USB ENGINEERING CHANGE NOTICE

Title: Pull-up/pull-down resistors

Applies to: Universal Serial Bus Specification Revision 2.0

Figure 7-22. Variable Pull-up Example

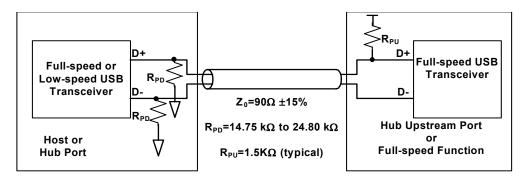
If a variable RPU is implemented, then the resistance switches from its low-resistance value (900Ω to 1575Ω) to its high-resistance value (1425Ω to 3090Ω) when a J-K transition is detected on the bus. This change must occur within 0.5 bit times of the transition. The resistance is switched from its high-resistance value to its low-resistance value when SE0 is detected on the bus for more than 0.5 bit times, or when the bus has been in the J state for more than 7 bit times. An implementation may implement either or both of these schemes. Figure 7-22 illustrates an implementation of a variable RPU.

R_{PU1} = 900 Ω to 1.575 $k\Omega$ R_{PU2} = 525 Ω to 1.515 $k\Omega$
